Immingham Green Energy Terminal

Second Statutory Consultation: Project Changes and Preliminary
Environmental Information Report Addendum

Associated British Ports

May 2023

Figure 6.1

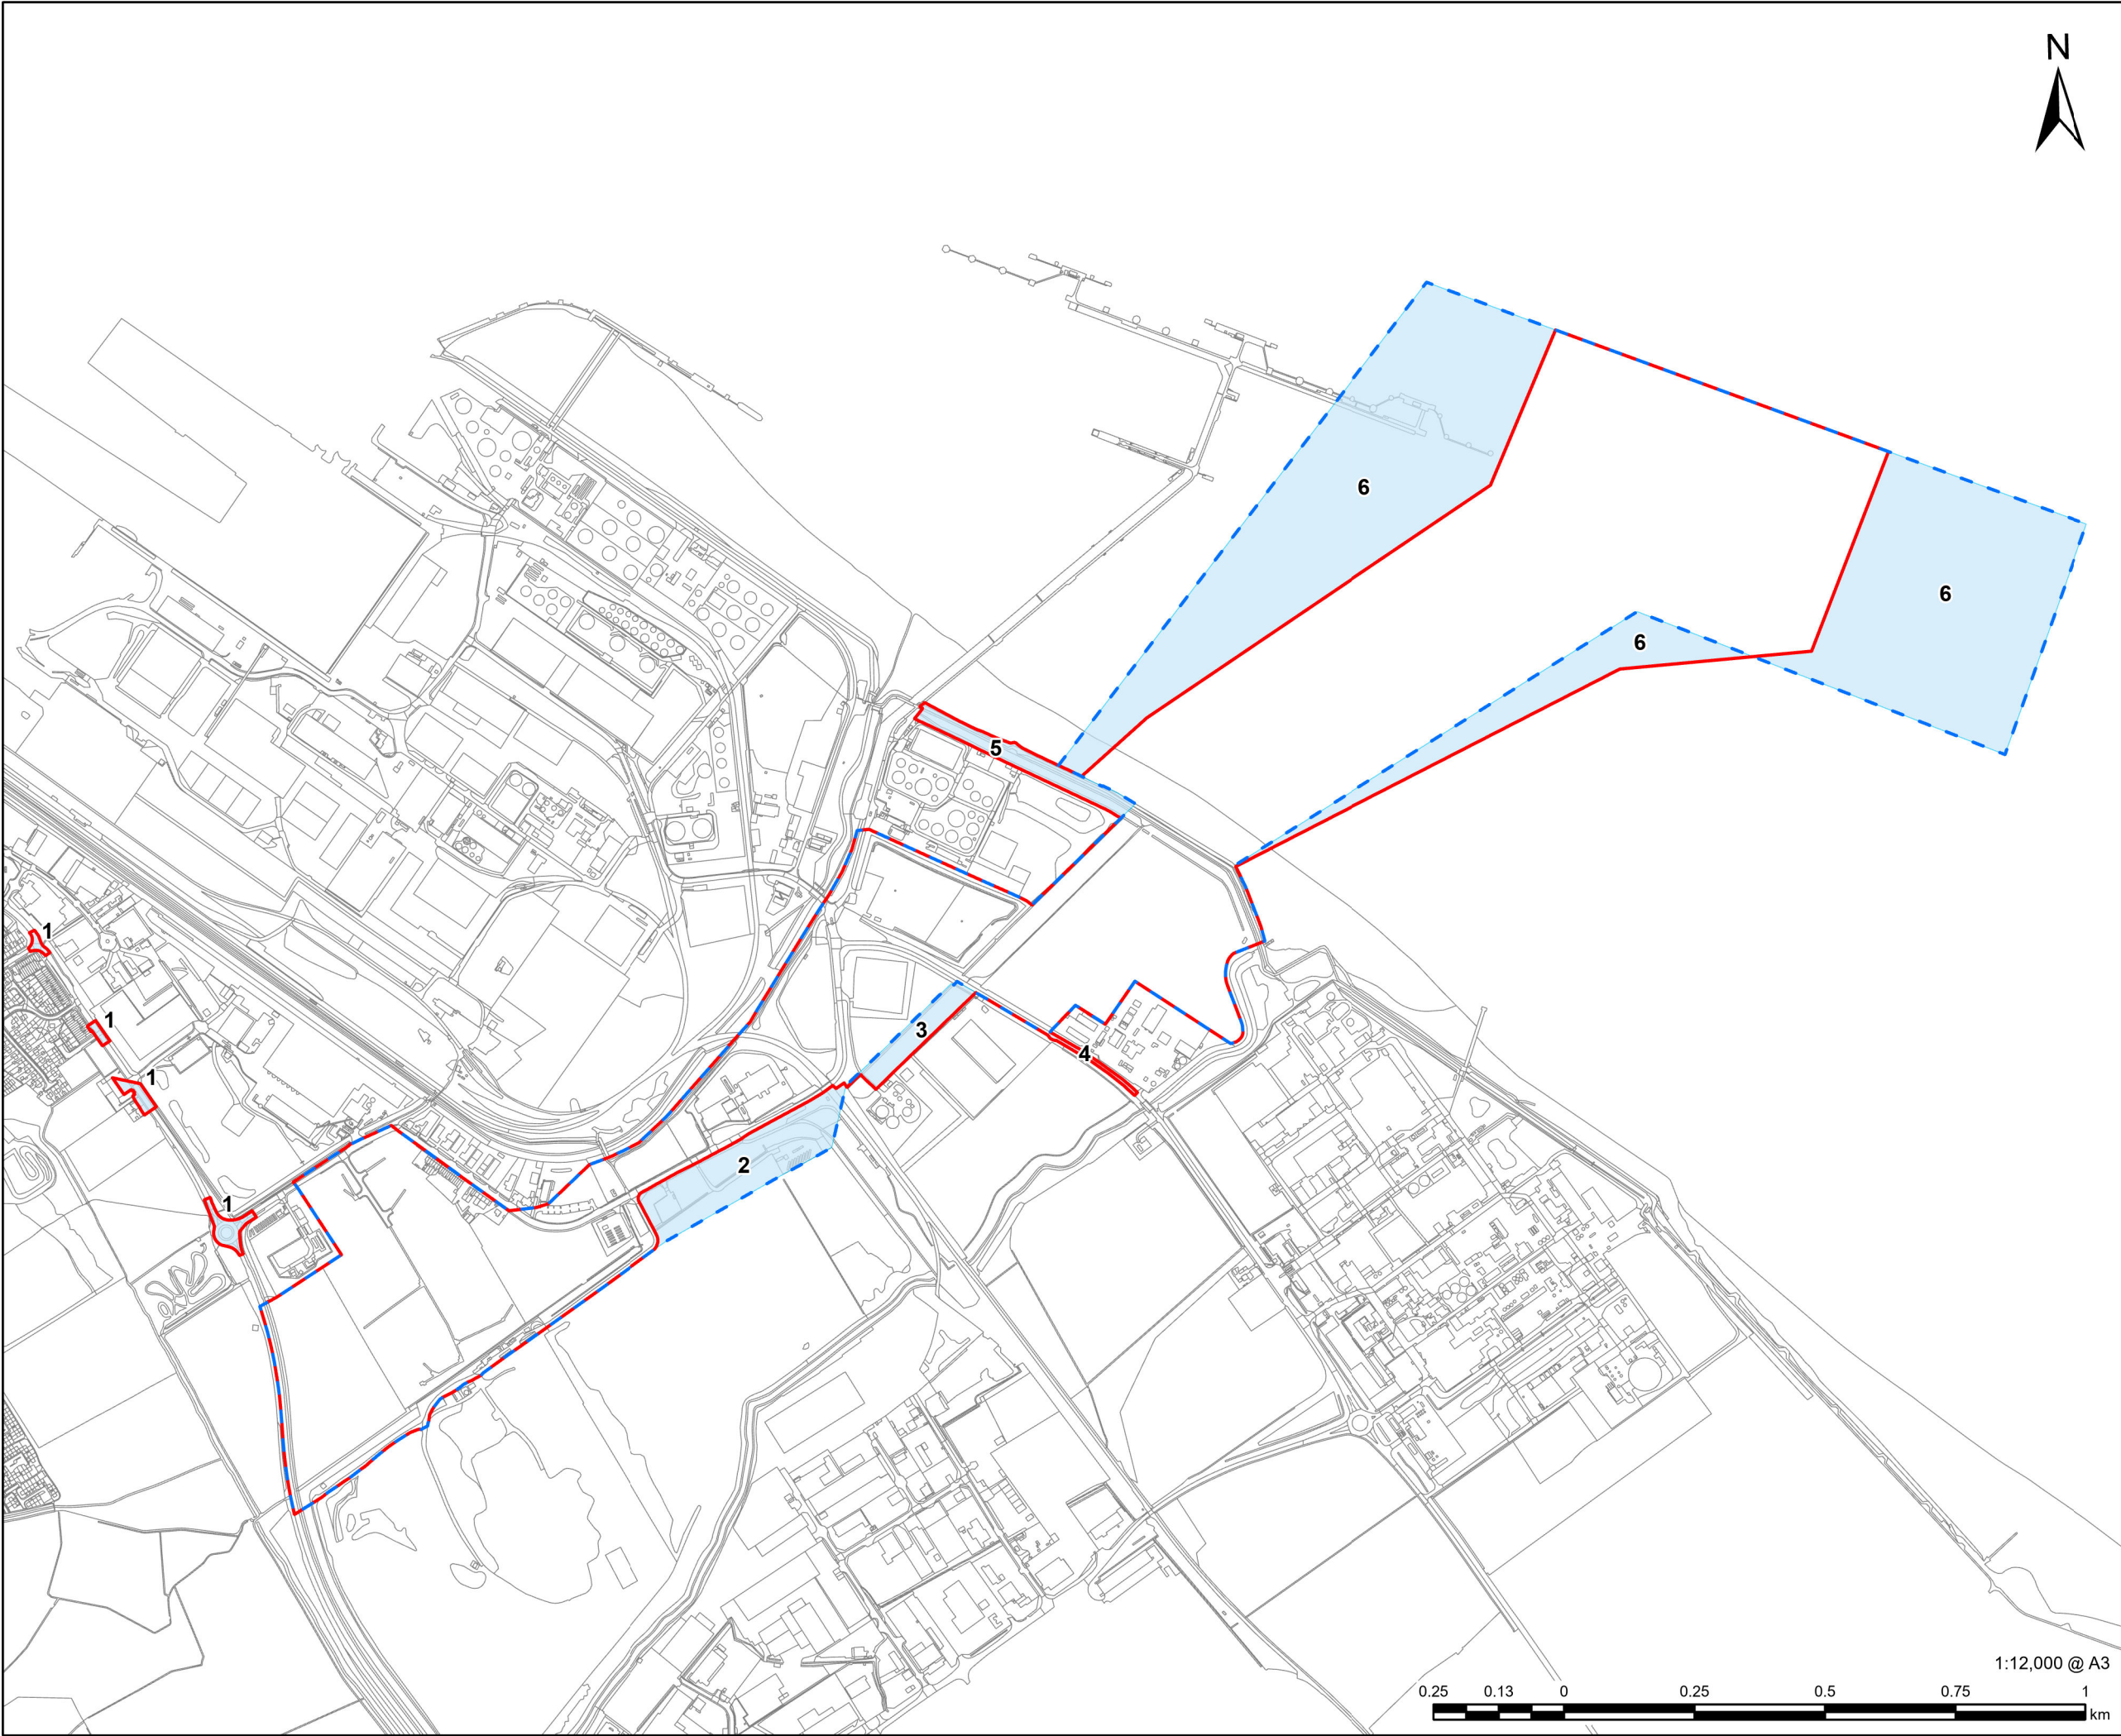
6.2.1 As a result of the design development for the Project, evaluation of consultation responses and further consideration of safety matters, the site boundary has been amended since the first Statutory Consultation. A total of six changes are proposed. These are shown on **Figure 6.1** (where the blue lines represent the changes to the site boundary) and are listed below:

1. Inclusion of four areas along Kings Road (see Change No. 8 below);
2. Removal of an area of land south of Queens Road which, following further design development, is now not required for the proposed pipeline corridor which will link the West and East Sites;
3. Inclusion of the southern part of the Long Strip woodland (see Change No. 7 below);
4. Inclusion of an additional section of Laporte Road (see Change No. 6 below);
5. Inclusion of an extended section of the sea wall (see Change No. 7 below); and
6. Re-orientation of the area of works in the marine area (removal of two large areas and inclusion of a third smaller area, see Change No. 2 below).

Plate 6.1: Illustrative Marine Layout (revised)

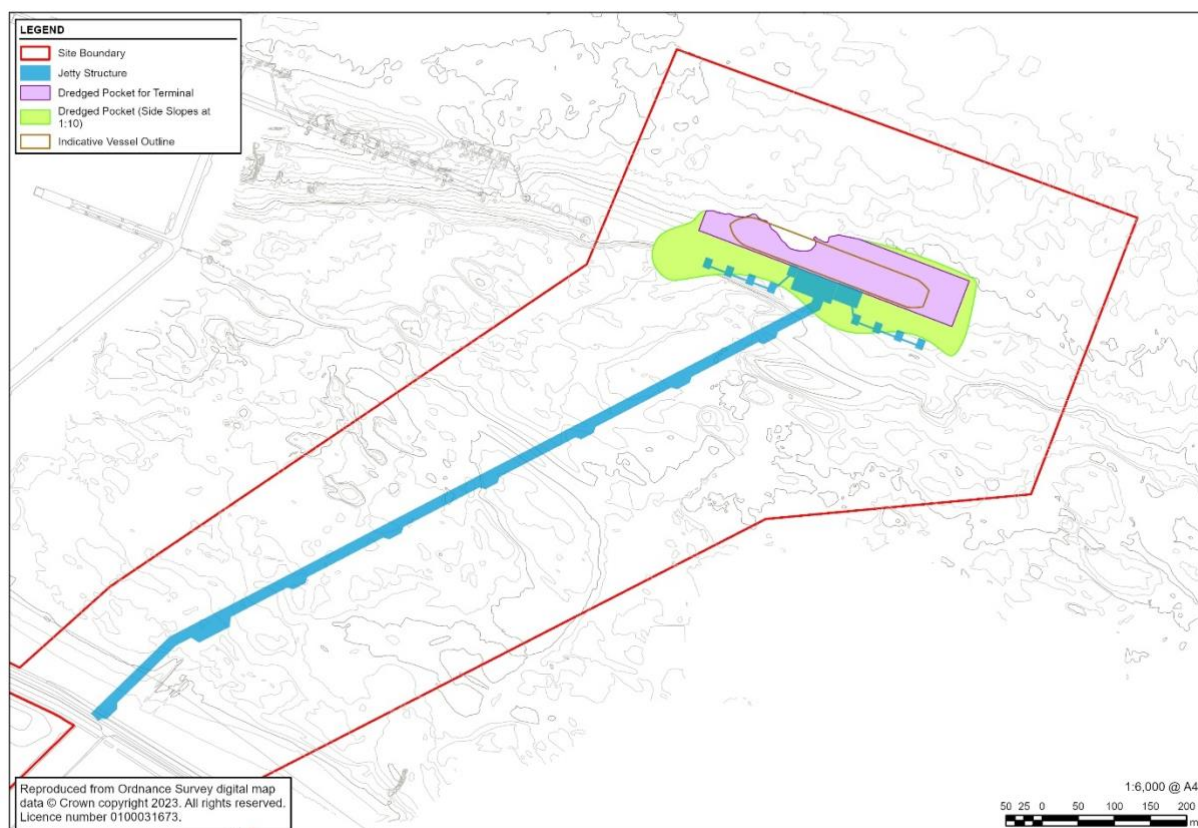
6.3.1 In the first Statutory Consultation a two berth design was presented since at this preliminary stage in the Project design it was thought that two berths would be needed to accommodate a wide range of vessel sizes expected to make use of the proposed jetty. However, further design work has been undertaken to refine the design of the jetty and a single berth design has been confirmed as being able to accommodate the full range of vessels expected.

6.3.2 In addition to the changes to the berth requirements, extensive optioneering has been undertaken to define the appropriate position for the jetty in relation to the existing navigation channel in the Humber and the jetty position relative to existing infrastructure. A new illustrative design has been developed which is broadly similar to the previous illustrative design in scale and orientation but as noted above now supports a single berth. The reduction to a single berth and the working widths associated with the amended new jetty orientation have required the update to the proposed marine site boundary explained under Change No 1. above (and shown on **Plate 6.1 below**).

6.3.3 Development consent is sought for these works to be constructed within the marine area shown. The updated illustrative layout is provided as an example of what the marine layout could look like however any changes to an illustrative layout do not constitute a formal change to the works for which approval is intended to be sought.

Plate 6.4: Speed Limit adjustments to Laporte Road

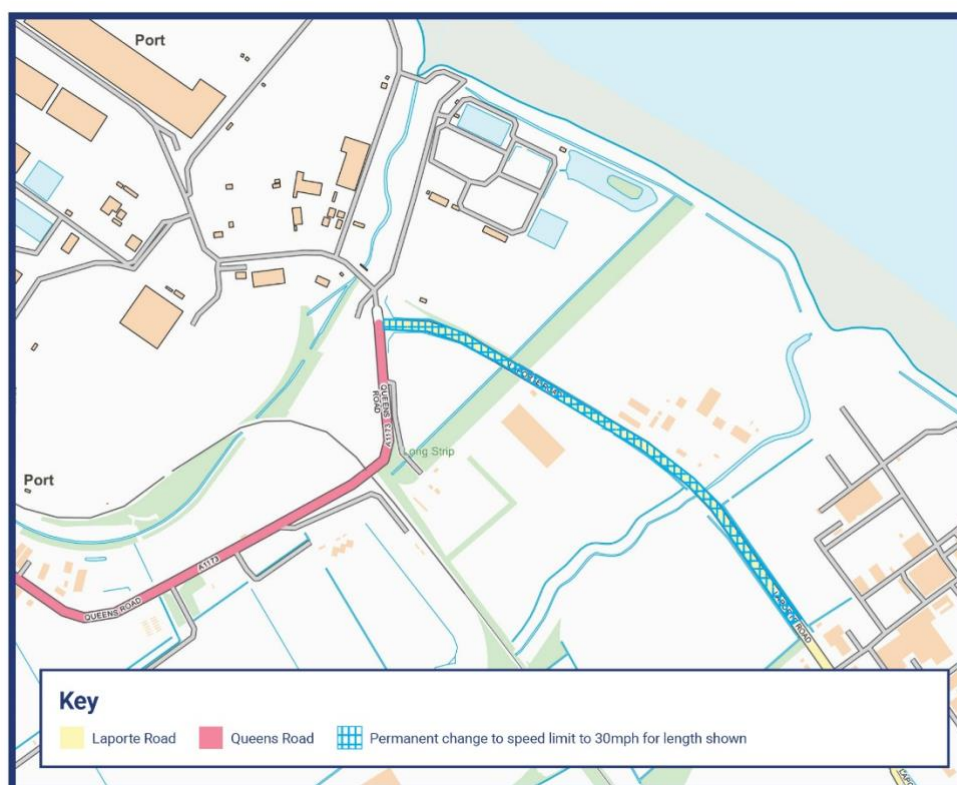
6.7.1 The speed limit on Laporte Road at present has multiple changes and varies between the national speed limit and 40mph. Both the construction and the operation of the project will require access and egress points from the East Site and the temporary construction area on to Laporte Road.

6.7.2 Since the first Statutory Consultation and to ensure the safety of road users a permanent reduction to the speed limit on Laporte Road has been determined to be necessary. A permanent 30mph speed limit is therefore proposed for the length of Laporte Road between the junction with Queens Road and the Tronox site entrance and this change is supported, in principle, by NELC. The length shown of Laporte Road to which these changes are applicable is shown in **Plate 6.4** below:

Plate 6.5: Changes to Public Rights of Way and Public Access

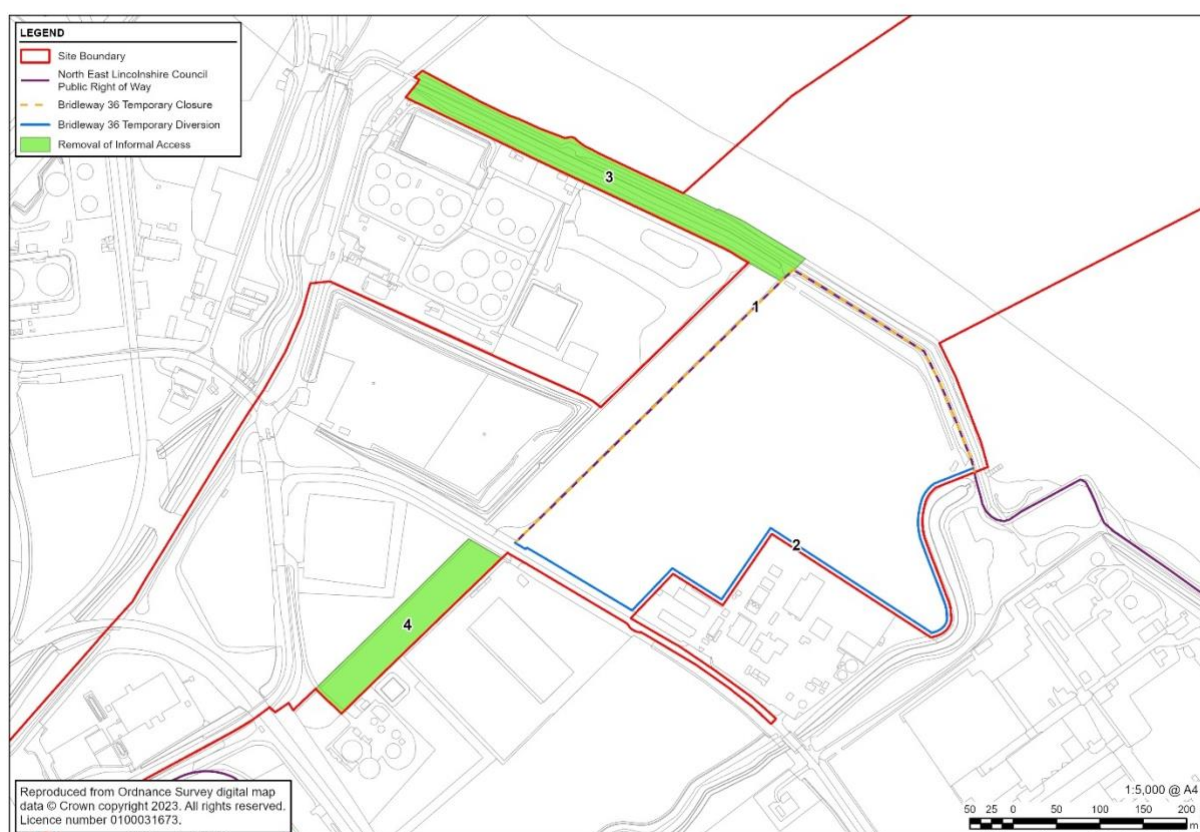
- 6.8.1 As explained at the first Statutory Consultation, the part of Public Bridleway Number 36 which runs from Laporte Road to the sea wall, along the east side of the Long Strip woodland, see 1 on **Plate 6.5**, would need to be closed along this alignment during the first phase of construction of the Project because of the use of the large arable field immediately to the east as the main temporary construction area. At the first Statutory Consultation it was explained that the Bridleway would be *either* temporarily closed or diverted.

- 6.8.2 Reflecting feedback received during the first Statutory Consultation, a decision has been taken to provide a temporary Bridleway diversion route (2 on Plate 6.5), along the north side of Laporte Road and around the eastern edge of the main temporary construction area to reconnect with the retained Bridleway, but further east on the sea wall than at present. Once the first phase of construction is completed (currently assumed to be a 2.5 year period) and the temporary construction area has been removed, the Bridleway would be re-instated on its current alignment and the temporary diversion would be closed.
